Improved PRBS31 testing

Piers Dawe
Avago Technologies

Relates to D2.0 comment 57

Example 1
100G module
tested from
electrical side

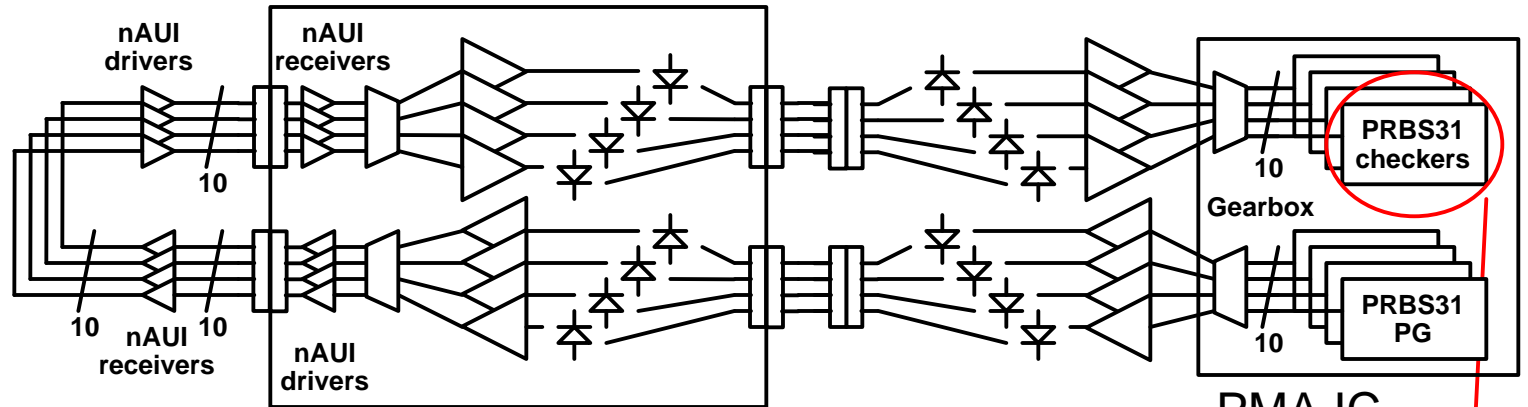
- Want to test **WHOLE** module
 - without assuming that its internal ICs are working perfectly
 - May expect Ethernet switch to check out a new module as in example 1

Example 2
100G module
tested from
optical side

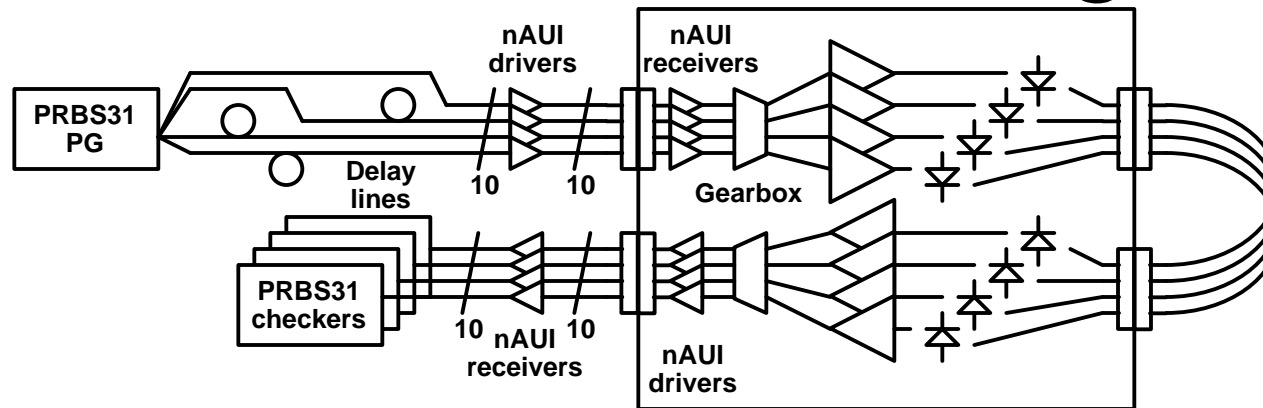
PMA IC
used as a
tester **See later**

Example 3
Module tested
from electrical
side, single PRBS
generator

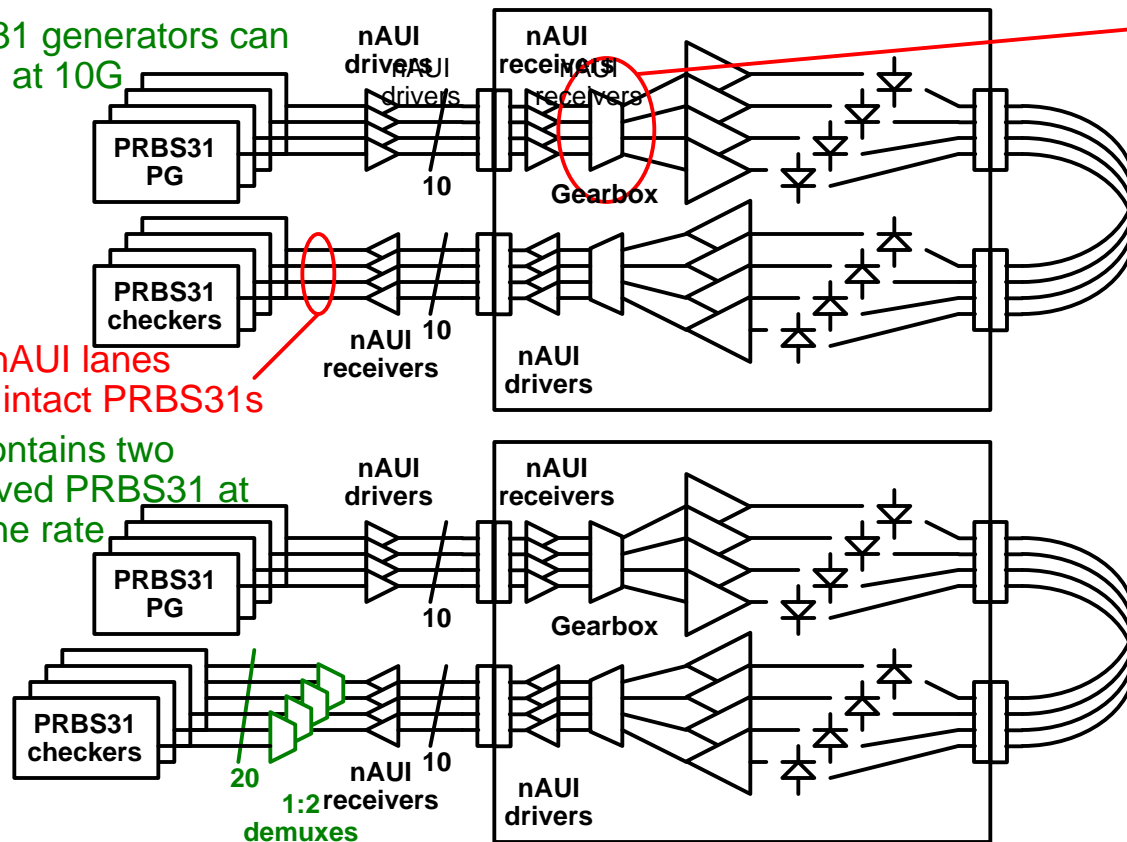
- Want to keep test costs down
- Existing 10G test equipment much cheaper than new or 25 G test equipment

PRBS31 generators can remain at 10G

Not all nAUI lanes contain intact PRBS31s

Each contains two interleaved PRBS31 at PCS lane rate

100G Gearbox has to split up at least 2 of the 10 nAUI lanes and divide them across 5G lanes

If checkers are in test equipment, we can do this without asking committee's permission

If checkers are in product, committee should bless the check-PCS-lanes option

- Hypothetical "serial" error checkers shown
- In practice, signal inside IC would be more parallel than this (<5G per lane) anyway
- Therefore VERY few extra gates needed
